TRANSMITTAL OF RESPONSES TO THE OHIO ENVIRONMENTAL PROTECTION AGENCY COMMENTS ON THE 2003 SITE ENVIRONMENTAL REPORT

RESPONSES TO OHIO ENVIRONMENTAL PROTECTION AGENCY COMMENTS ON THE 2003 SITE ENVIRONMENTAL REPORT

FERNALD CLOSURE PROJECT FERNALD, OHIO

RESPONSES TO OHIO ENVIRONMENTAL PROTECTION AGENCY COMMENTS ON THE 2003 SITE ENVIRONMENTAL REPORT (51350-RP-0024, REVISION 0 FINAL)

MODELING RESULTS IN SUPPORT OF RESPONSE TO COMMENT #7

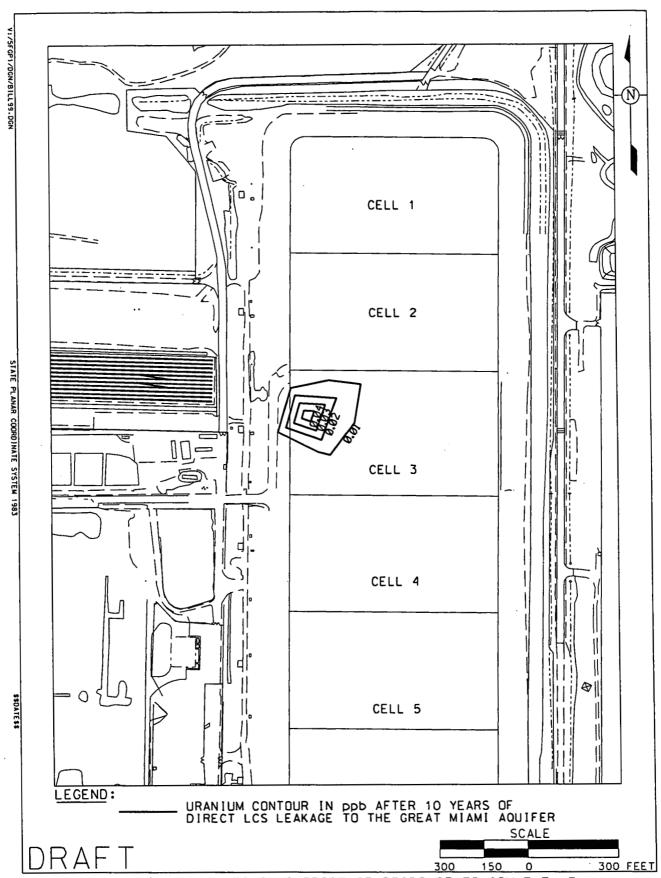
Fifteen percent of the control chart limits were exceeded in 2003. DOE minimizes the significance of the exceedances in the text discussions by suggesting that they are the result of groundwater aging or pre-existing contamination. The respective FRLs for the monitored constituents are used in the text as proxies for comparison to the data. While pre-existing

The large VAM3D model (120 x 112 x 12) was run with a single source term at the approximate water table (model layer 3 which approximates model layer 12 in the zoom model) corresponding to a hypothetical leak in the liner penetration box beneath Cell 3.

Source term strength was calculated from the Cell 3 LCS flow information noted above and the maximum monthly average leachate total uranium concentration recorded for the first half of 2004 (February 2004 @ 71 µg/L). Thus, a flow rate of 0.216 gpm (42 cubic ft/day) at a concentration of 71 µg/L (4.43 x 10³ nano-lbs/cubic ft) was used for the source term.

A no-pumping scenario (including no pumping from the Southwest Ohio water collection wells) was used with dry (October 1999) boundary conditions and run for 10 years. This is anticipated to give the maximum concentration since the aquifer would have minimum flow under these conditions.

A Kd of 1.78 L/Kg was used since a file for the large model with Kd = 3 L/Kg was not readily available. Given the extremely low concentrations in the aquifer, Kd shouldn't make an appreciable difference in the results. As shown in the attached figure, the results of this modeling indicates that after 10 years of direct leakage to the aquifer, maximum uranium concentrations in the aquifer as a result of the leak would be about 0.04 µg/L. This

concentration would be undetectable in the OSDF Great Miami Aquifer monitoring wells given the current "background" levels of uranium in the aquifer beneath the OSDF.
